Bulletin No.: PIP5745A
Published date: 03/23/2021

PIP5745A MIL illuminated with DTC P026A

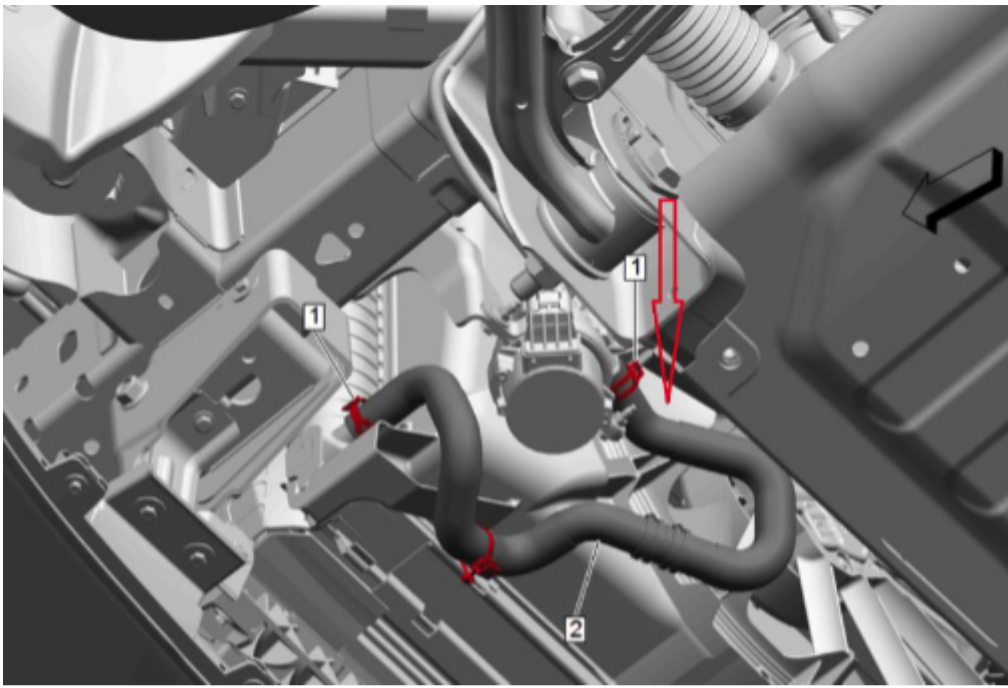
Involved Region or Country:	North America
Condition:	A vehicle may arrive at the dealer with the MIL illuminated and DTC P026A set.
Cause:	This may be due to a kinked hose at or near the low temperature auxiliary coolant pump.

If this condition is encountered, loosen the hose clamp and rotate the hose to allow for proper coolant flow.
